Charles River Watershed Association

December 9, 2011

***RE: Chapter 91 license application for EFEKTA House, Inc., Office Building,
Cambridge, MA,***

Figure 1. Historic extent of the Millers River overlaid on present conditions

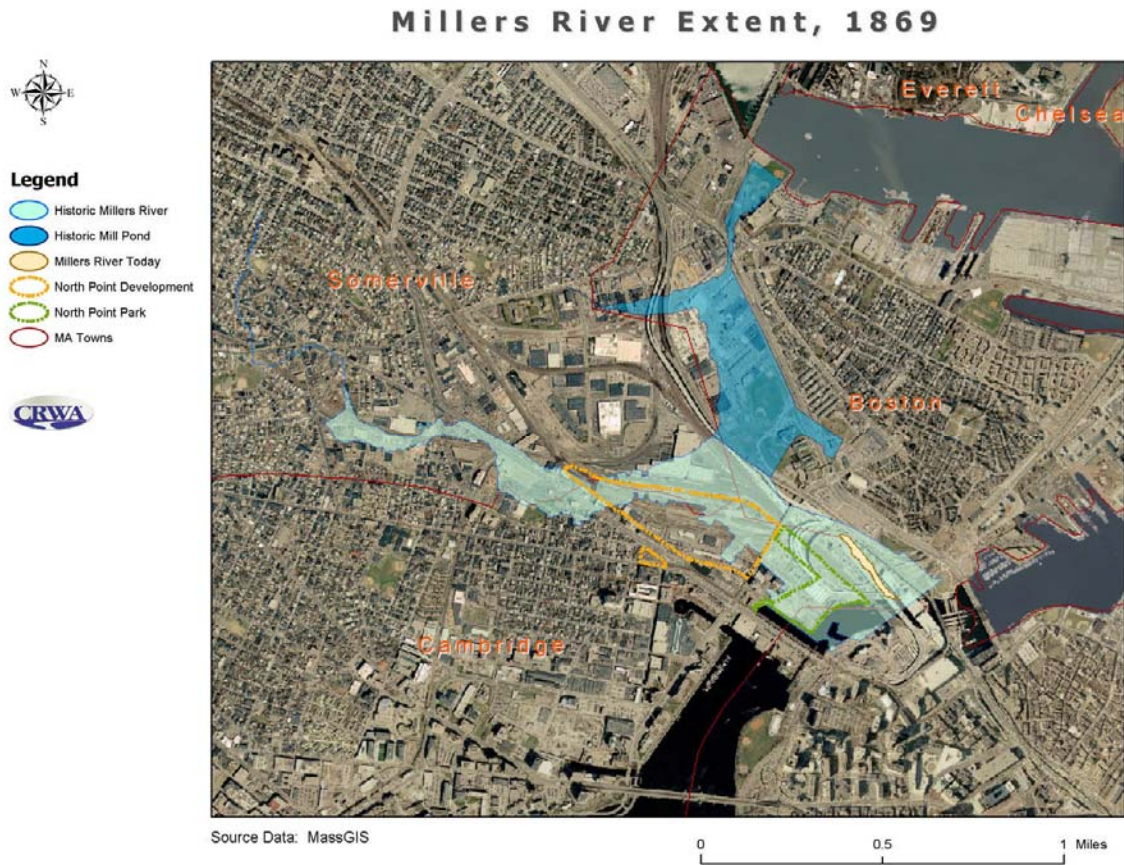
Drainage is a significant issue in the development of filled tide lands and the applicant should to address drainage issues not only at the site level, but also at a larger sub-watershed level. Since the filling of the tidelands and the historic Millers River (see fig. 1 below), the original subwatershed of the Millers encompassing parts of East Cambridge, Somerville and Charlestown has suffered from serious flooding and other stormwater related issues.

The inadequacy of the drainage infrastructure put in place during the filling has created a situation that conventional engineering approaches have only worsened. Consequently, any redevelopment that is undertaken in this area (especially in the downstream section of the drain shed) cannot be planned /designed without addressing the drainage impacts at the sub-watershed scale.

It is not clear whether the section of the site that drains to the existing infrastructure owned by the City of Cambridge and MassDOT discharges to the Charles River or the Cambridge or MWRA sewer system. This should be clarified in the SEIR. It is certain, however, that any new flows in the MWRA system have the potential to increase treated CSO discharges to the Inner Harbor and possibly also increase untreated CSO discharges at hydraulically related CSO outfalls. It is therefore critical that every attempt be made to keep any stormwater discharges from the site and its adjoining area from going into the combined system.
